Project: Denison Avenue Extension Class EA Study

Subject: Project Initiation Meeting – City of Brampton

RECORD OF MEETING

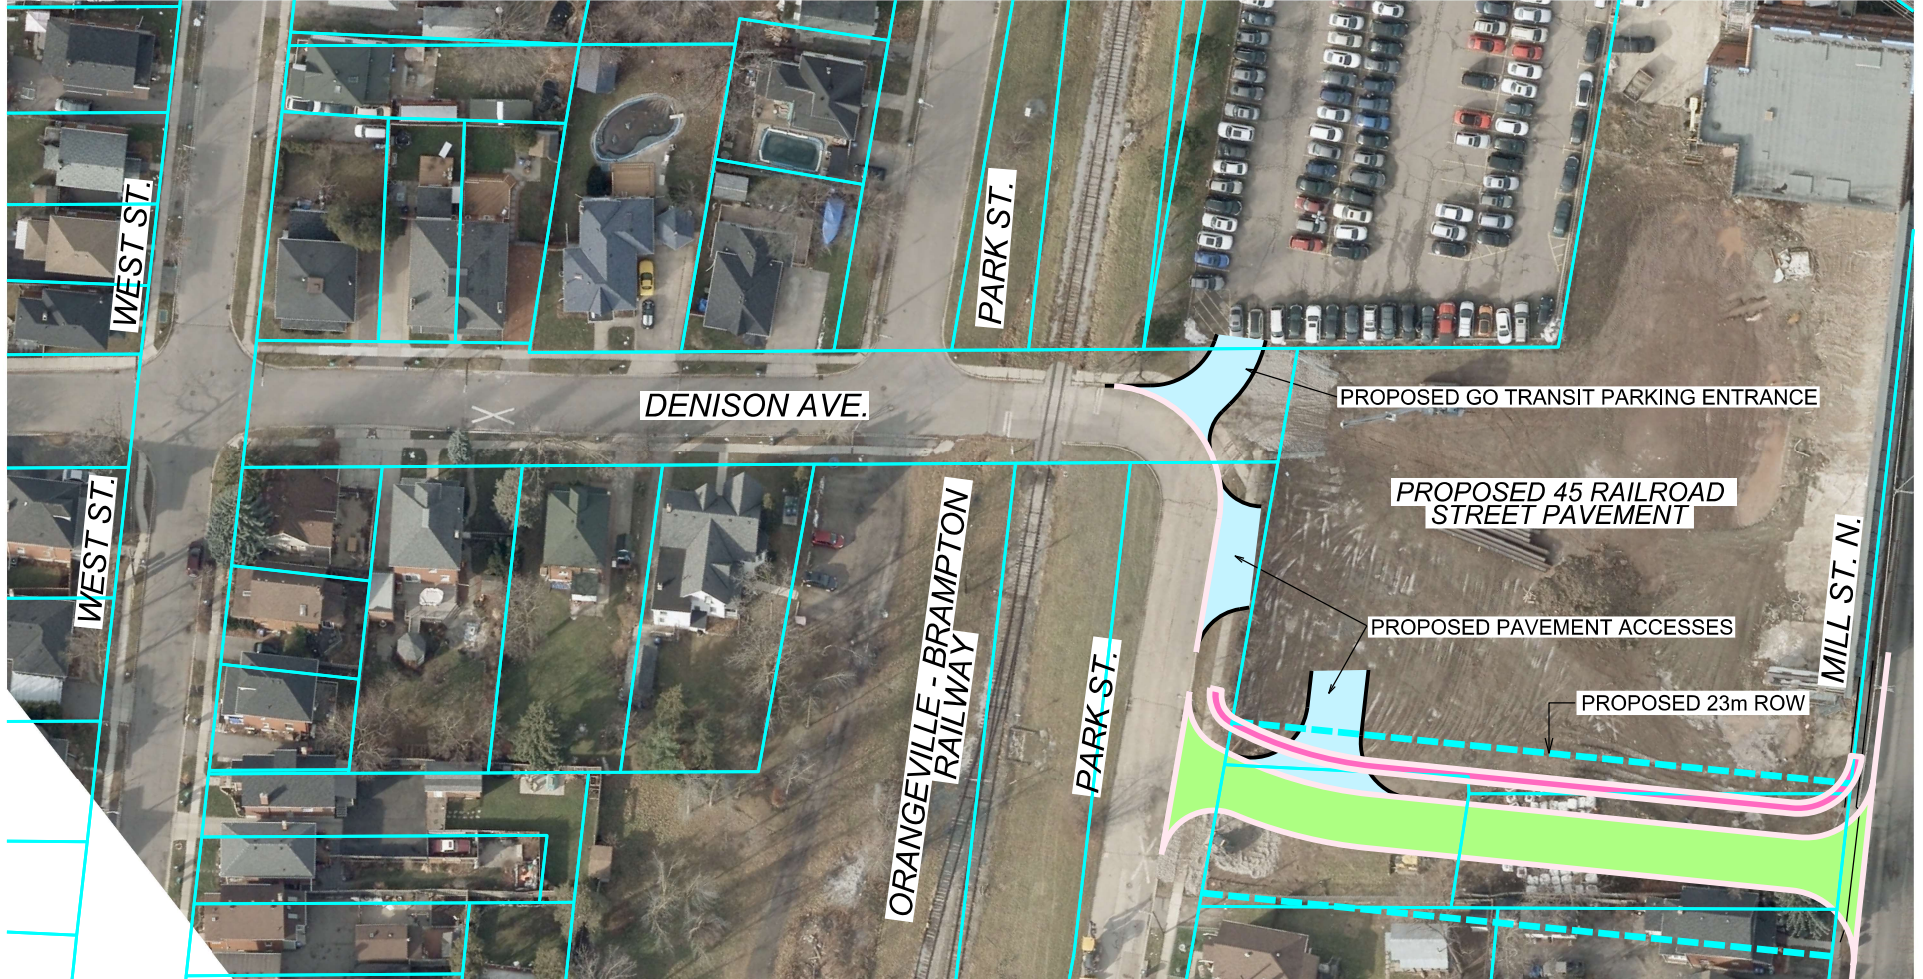
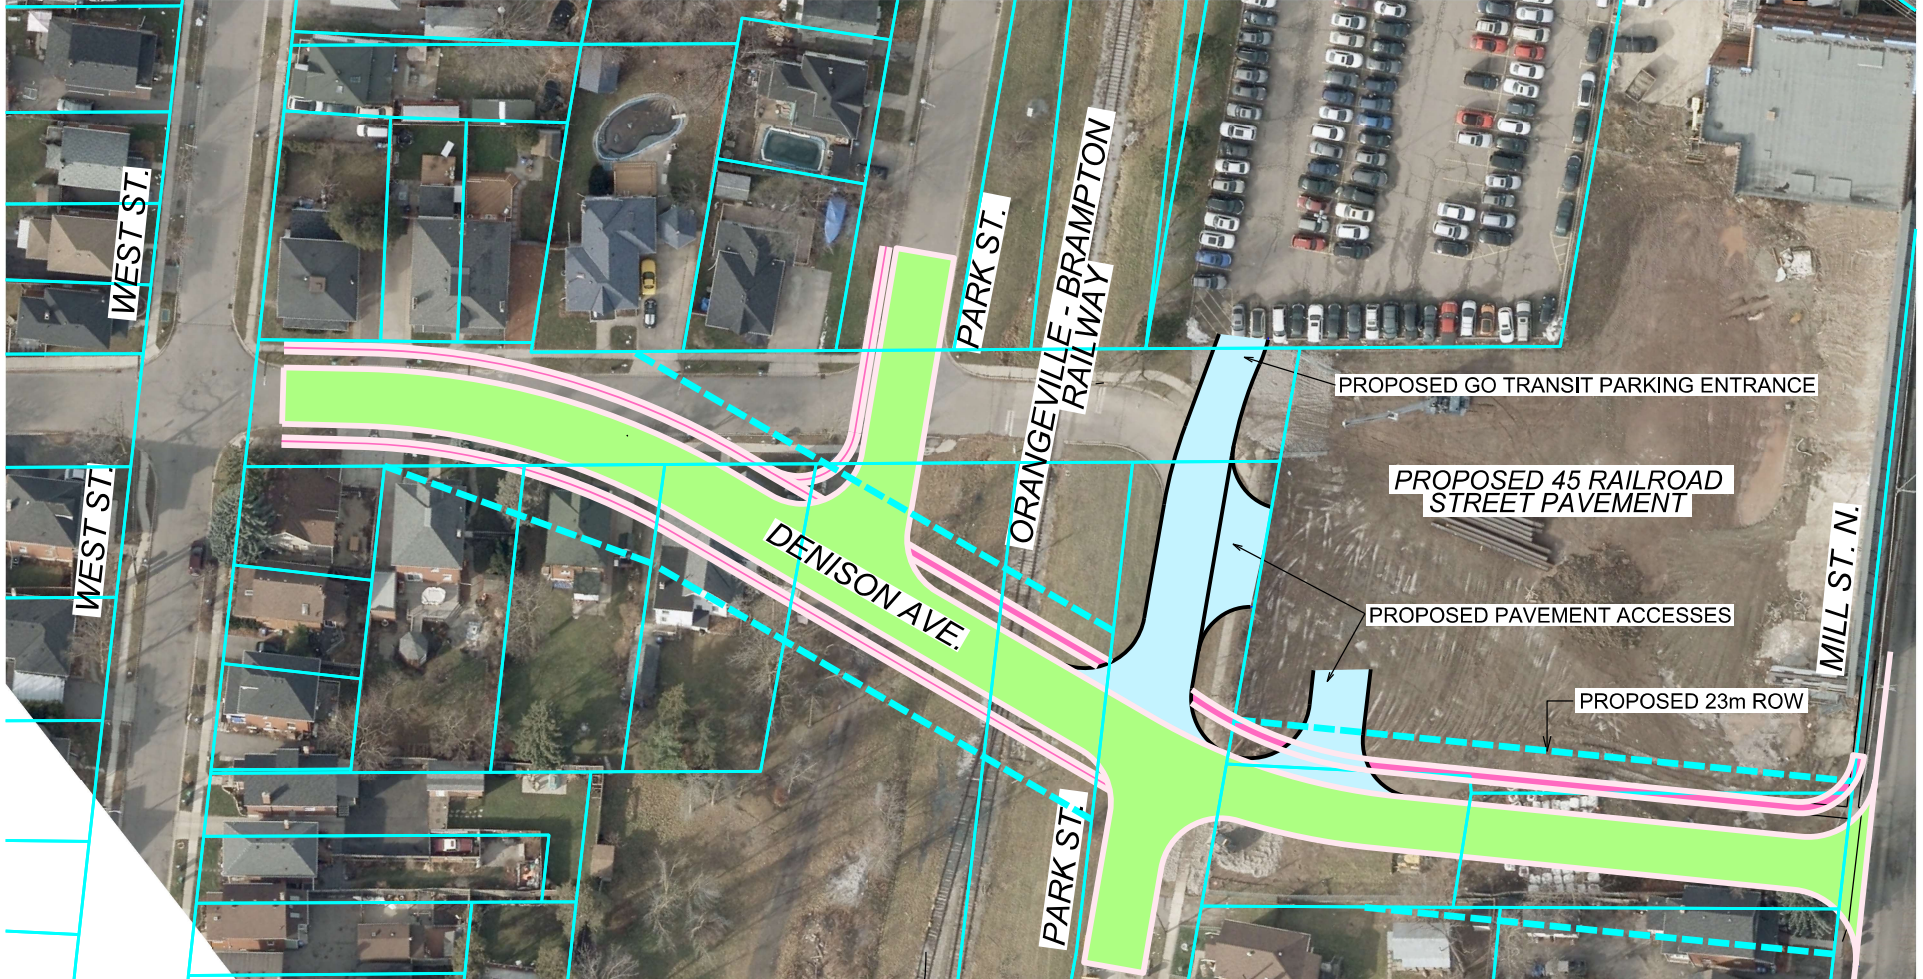
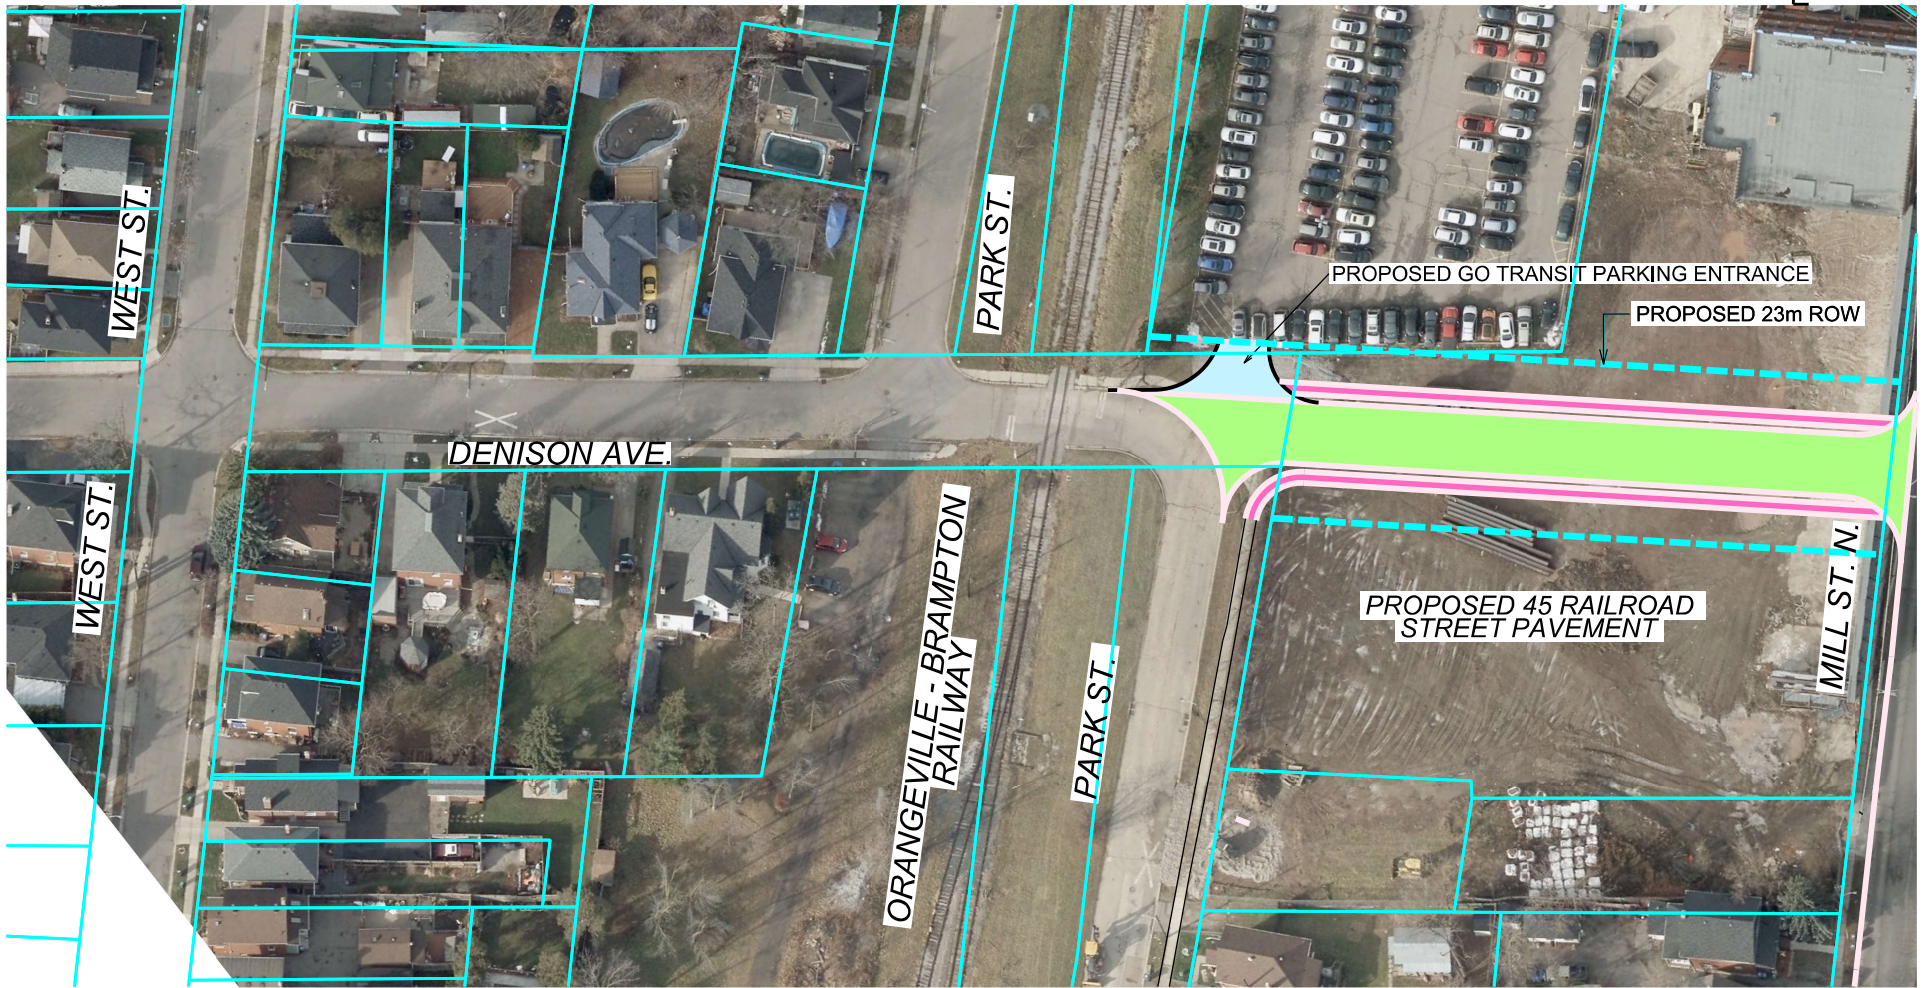
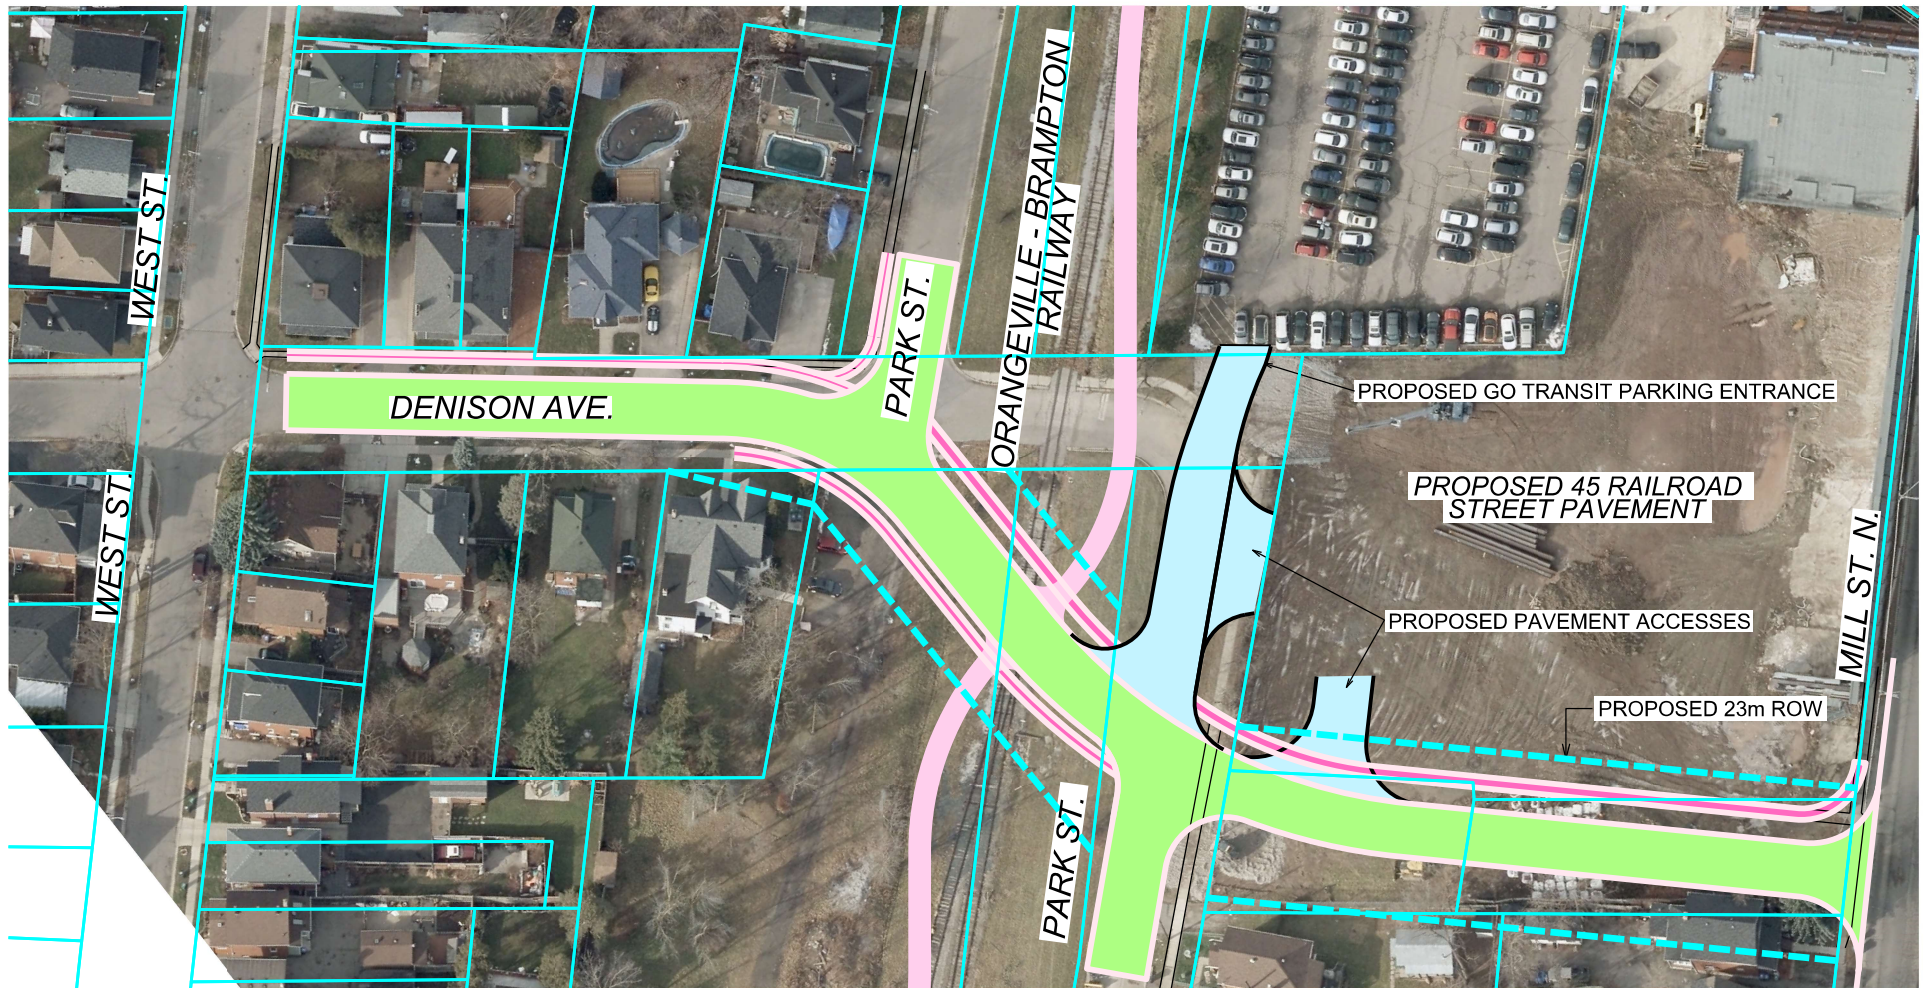
| AE | Review of Design Options (16, 17, 18,19) | <ul style="list-style-type: none"> • Remove reference to “Ultimate 23m ROW” and show only “Proposed ROW” since the 23m reference may be confusing • Alternative showing the “Ultimate” extension layout can be removed from the set • AE was asked to clarify if the 45 Railroad Street development plan does in fact show the proposed north side sidewalk on private property at the corners. |

Public Works & Engineering Capital Works
	DENISON AVENUE EXTENSION EA STUDY
TYPICAL SECTION	
SCALE: 1:1000	DATE:

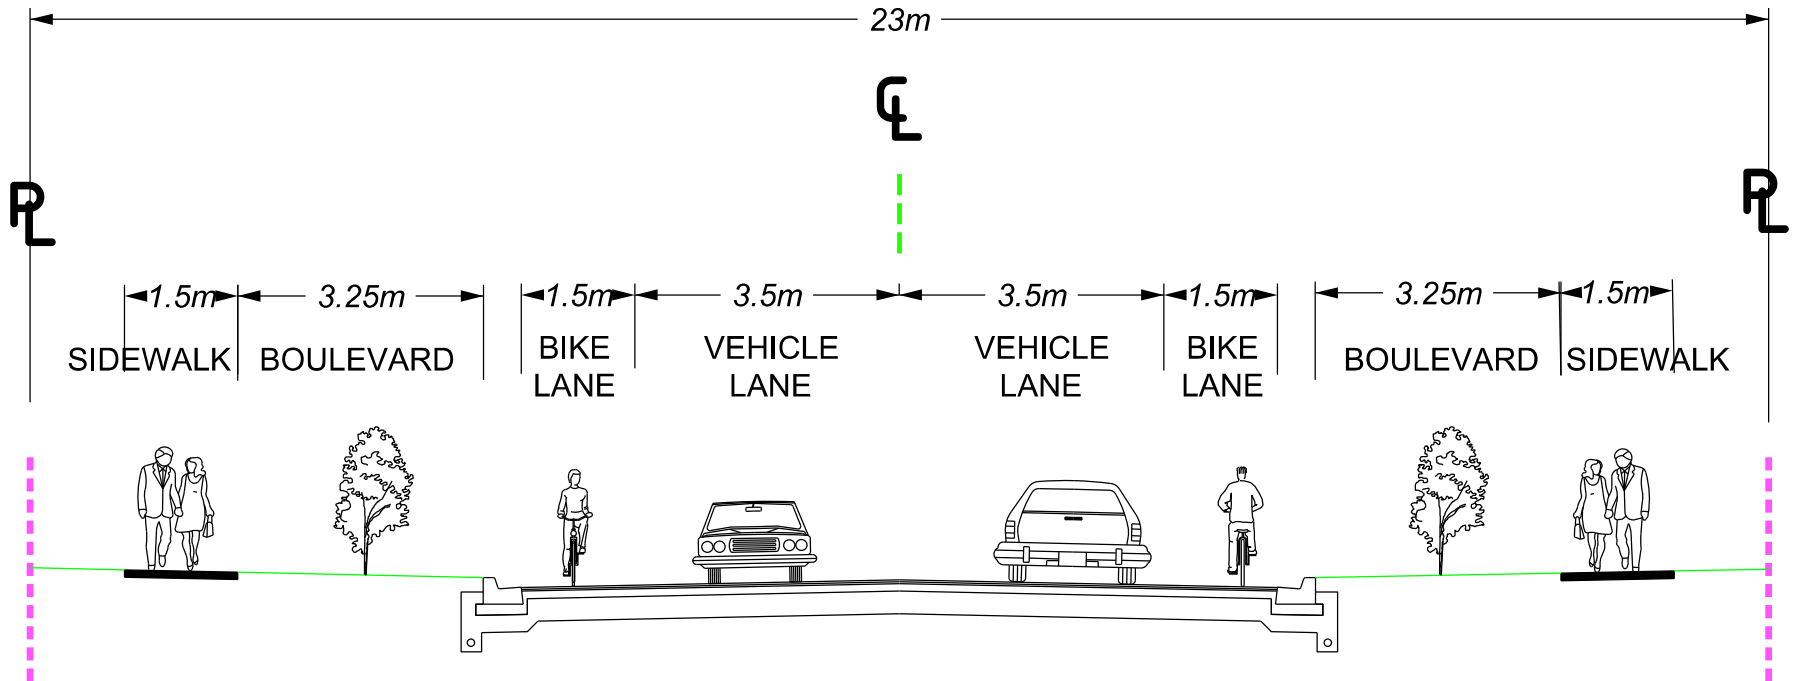
| AE | Review of Design Options for Denison Avenue Extension (15) | <ul style="list-style-type: none"> • Discussion was had regarding the proposed “Interim” and “Ultimate” typical cross-sections as shown • Consensus was to remove the title “Interim” and change to “Preferred” since it was undetermined if the full 23m right-of-way and CoB standard cross-section for a Minor Collector roadway would ever be implemented • Change “Ultimate” to “Potential Future” with reference to it being the CoB standard cross-section • Each cross-section to be presented separately on the page ‘Preferred’ presented ahead of ‘Potential Future’ • In the interest of providing on-road cycle facilities per the CoB Active Transportation Master Plan recommendations it was agreed to show a 3.75m wide “sharrow” lane for bikes and cars in lieu of the separate on-road cycle facility. This is also done in consideration of the lack of connecting cycle lanes and/or multi-use trails. |
